**CITY OF ISSAQUAH
DEVELOPMENT SERVICES DEPARTMENT
DEVELOPMENT COMMISSION**

STAFF REPORT

FILE NO.: COM16-00001

PROJECT: CLARK ELEMENTARY AND GIBSON EK CAMPUS

Fig.2. Existing Conditions

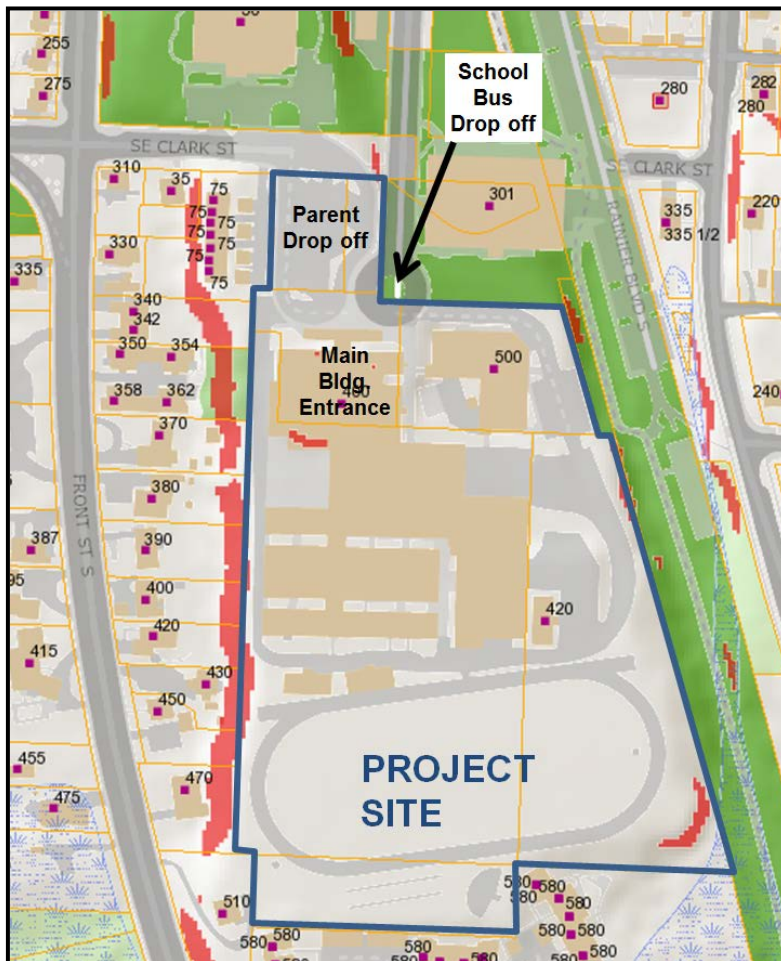
Staff Comments: Steep slopes are found along the east and west edges of the property, and immediately outside of the west property boundary. As mentioned earlier, there is a wetland area at the southeast corner of the campus. A critical areas report will be required, to evaluate the steep slopes and determine whether the slopes are man-made, and therefore exempt from the critical areas regulation, or not, which will require the project to meet the critical areas development standards prescribed in IMC 18.10.520. The geotech report will also be required to analyze impacts of ground disturbance and soil stability to support the proposed site development.

Per IMC 18.10.500, wetlands and associated buffers shall not be altered. It appears that an existing parking lot is encroaching in the wetland buffer, rendering this a nonconforming site condition. A critical areas report to verify the wetland boundaries, wetland type and corresponding buffer will be required as part of the Site Development Permit (IMC18.10.410.A). The dimensions of the buffers need to be shown on the site plan, and the critical areas report needs to demonstrate how the proposed buffer averaging meets the standards set forth in IMC18.10.650.D.5, Wetland Buffer Averaging Requirements.
